Port of San Francisco
Joint meeting of the
Port of San Francisco
Waterfront Design Advisory Committee
and
Bay Conservation and Development Commission
Design Advisory Committee

Staff Report

Meeting Date: July 14, 2014 – 5:30PM

Re: **Pier 70 Crane Cove Park Master Plan (“Park Master Plan”)**
(see: sfport.com/cranecovepark)

**DRB/ WDAC PUBLIC COMMENTS
(ON MAY 5TH, 2014 PLAN)**

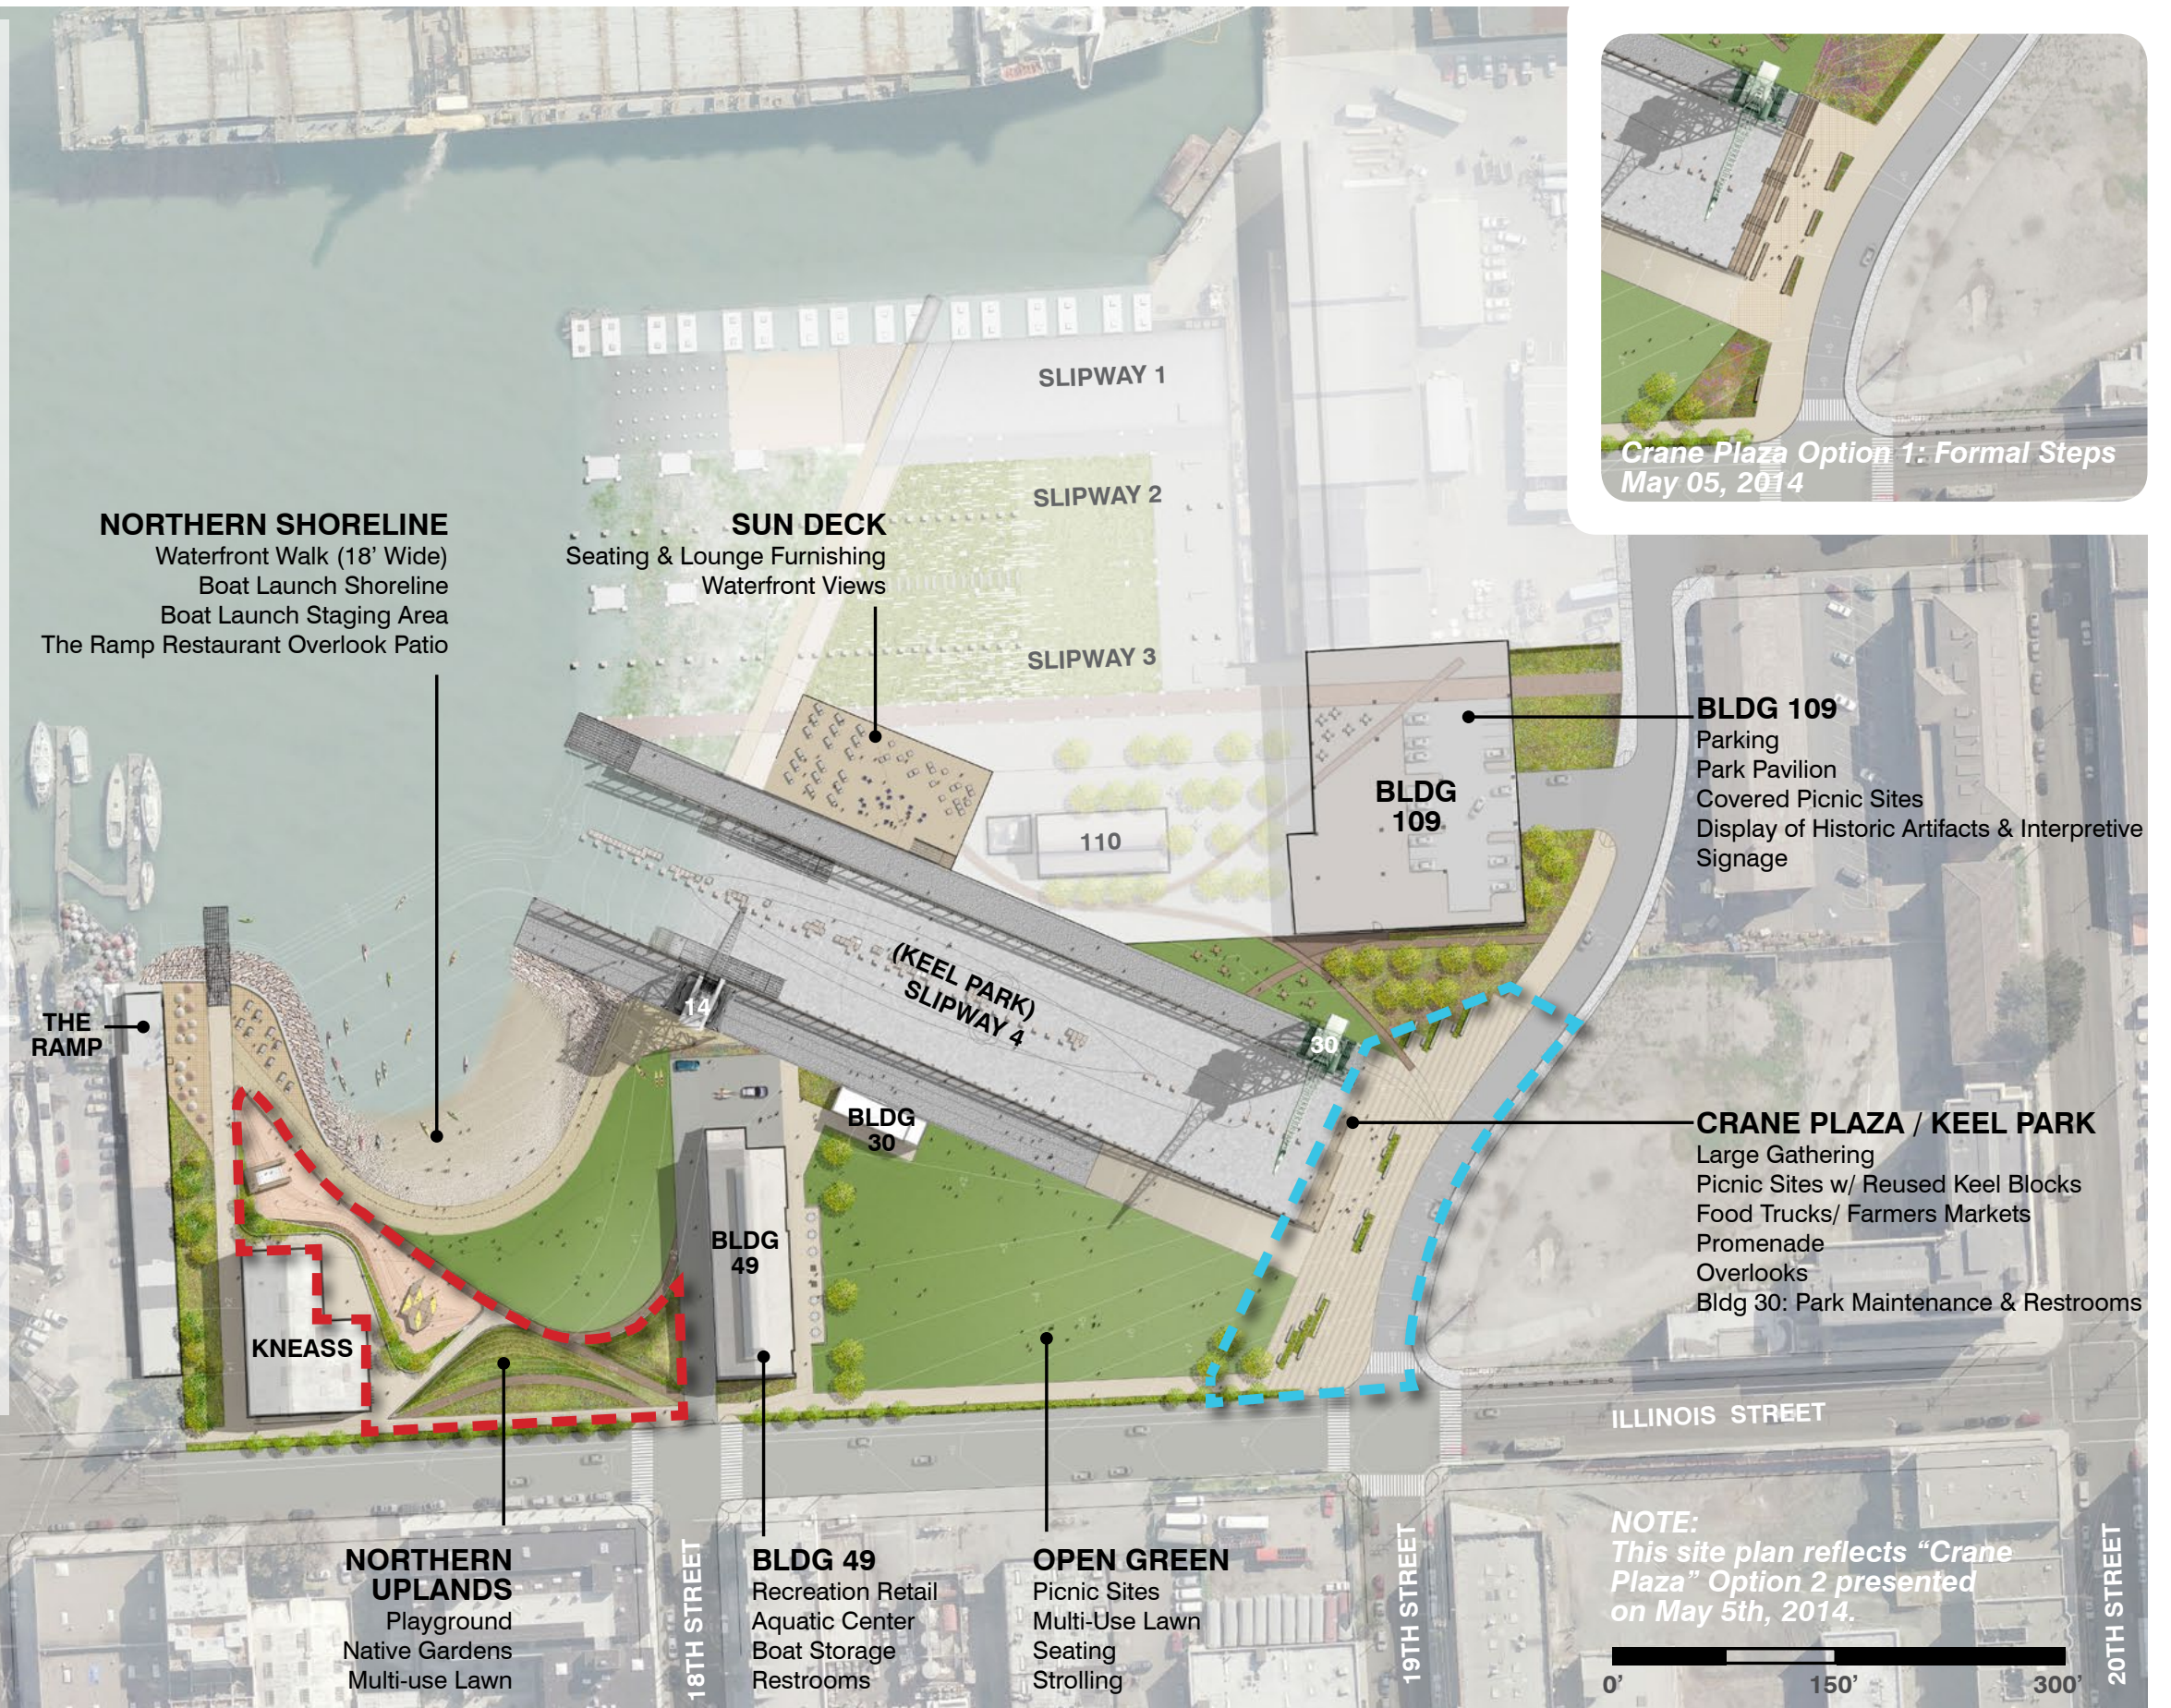
■ ■ NORTHERN SHORELINE AREA

1. **Playground** - Expressed concern about how the formal playground could negatively impact the redevelopment of the Kneass Building because of its close proximity and possible view blockage to the launch and Bay. Expressed concern with how the playground may interfere with the promenade circulation, and **requested that other locations and other playground options be explored;**
2. Expressed concern about the **height of the berm** adjacent to Illinois Street blocking views into the site.
3. Expressed concern about the amount of **native garden planting area**

■ ■ SLIPWAY 4 AND 19TH STREET

1. Requested a design be explored that blends the best attributes of both proposals presented: **universal access into the slipway;** and a **plaza space that creates a comfortable pedestrian environment** for appreciating the Slipway and activities within the Slipway.
